City of Olathe
City Planning Division

STAFF REPORT

Application:	<u>RZ19-0001</u> Rezoning from RP-3 to R-4 district and preliminary site development plan for Saddlewood Apartments
Location:	In the vicinity of 154 th Street and Brentwood Street
Owner	Saddlewood Associates, L.L.C.
Applicant:	Aaron G. March, Rouse Frets White Goss Gentile Rhodes
Engineer:	Jeff Skidmore, Schlagel & Associates
Staff Contact:	Dan Fernandez, Planner II

City of Olathe, Kansas
Plan Review Comment Responses

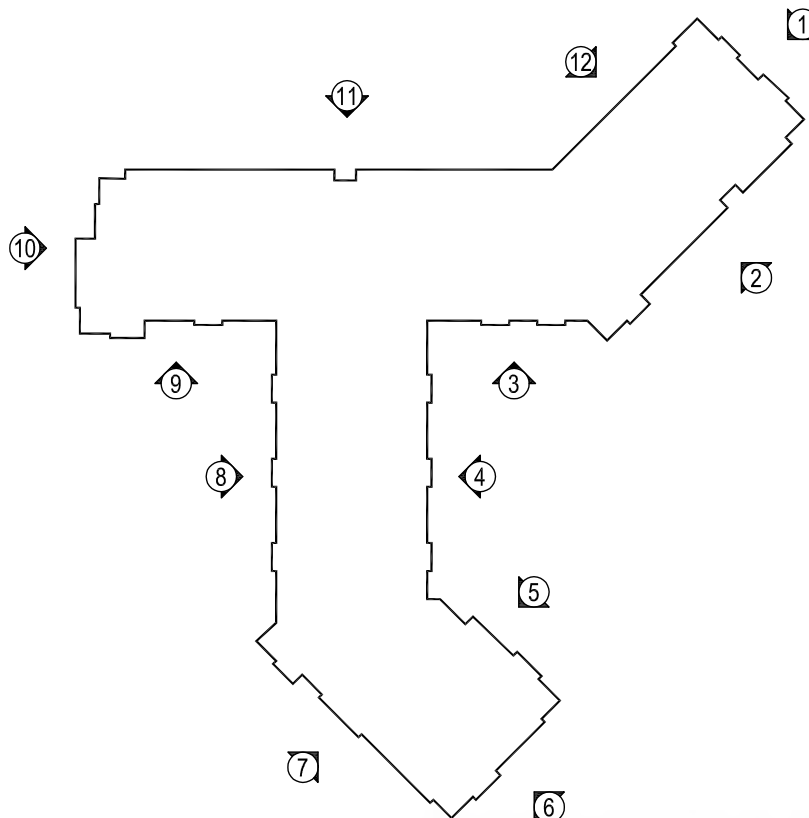
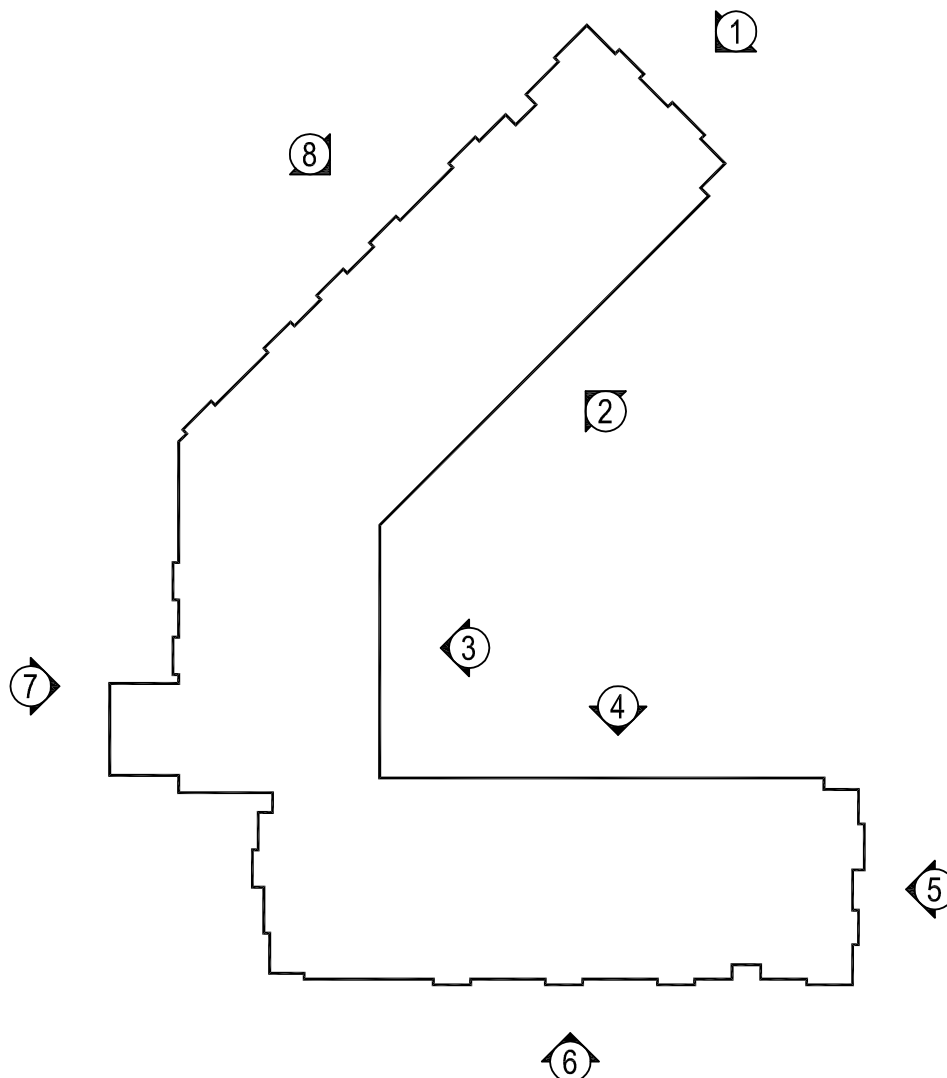
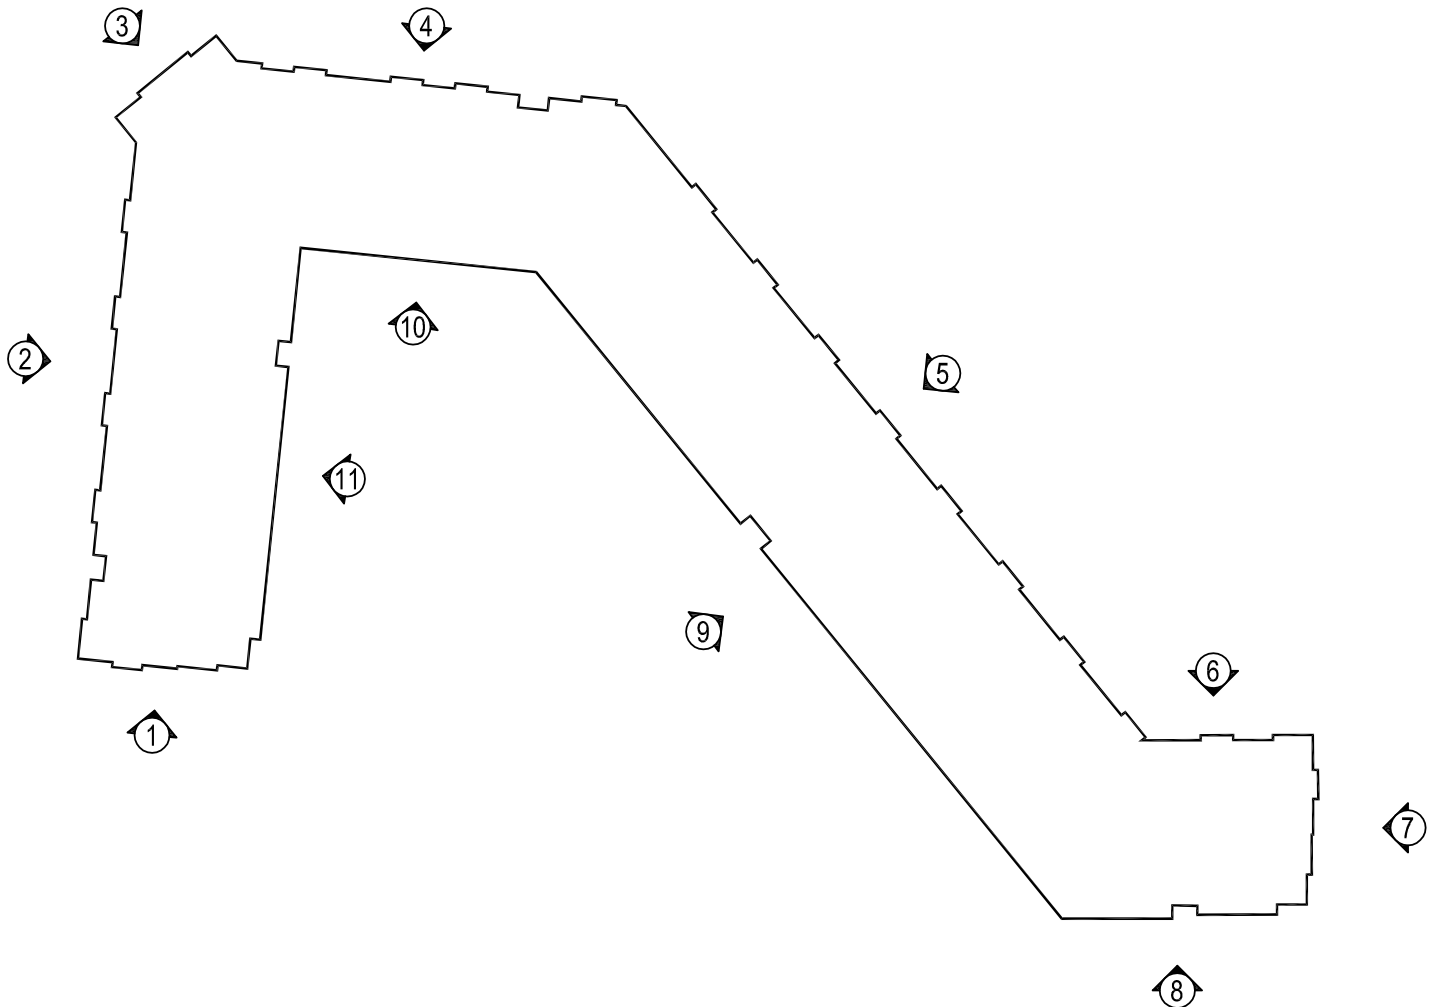
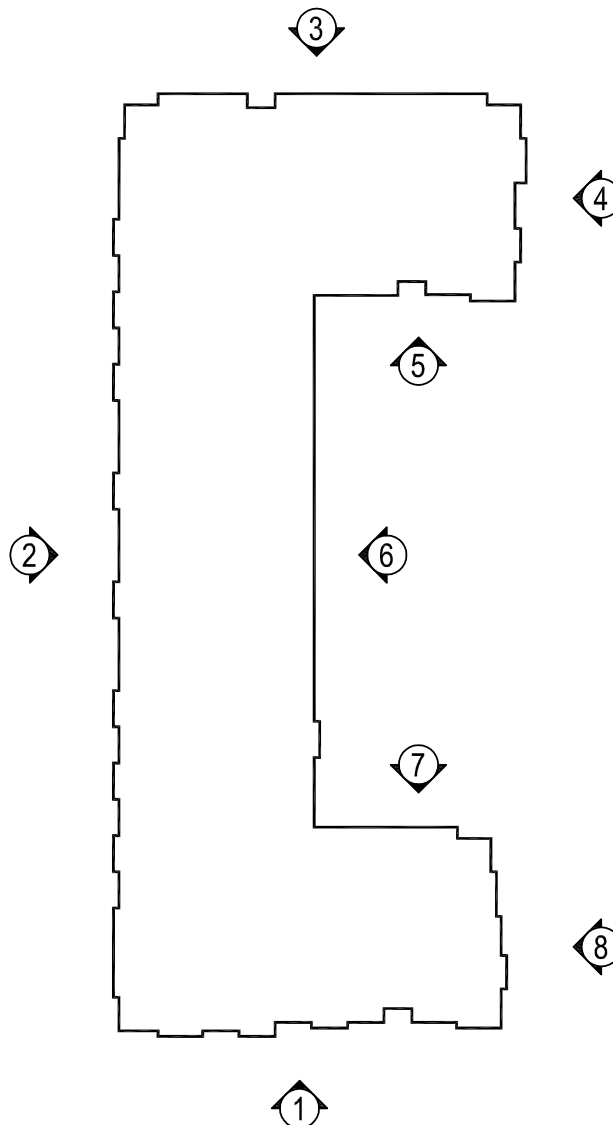
The proposed buildings are unique in shape and have more than just east, west, north and south elevations. Due to this, please refer to the material percentage sheet submitted by the applicant for the material percentages for all elevations. It should be noted that even though not all elevations are primary, each side of each building meets the primary façade requirement of 70% Category 1 materials.

Please use the table and key plans below for the percentage of materials by individual building for the Saddlewood Apartments development in Olathe, Kansas.
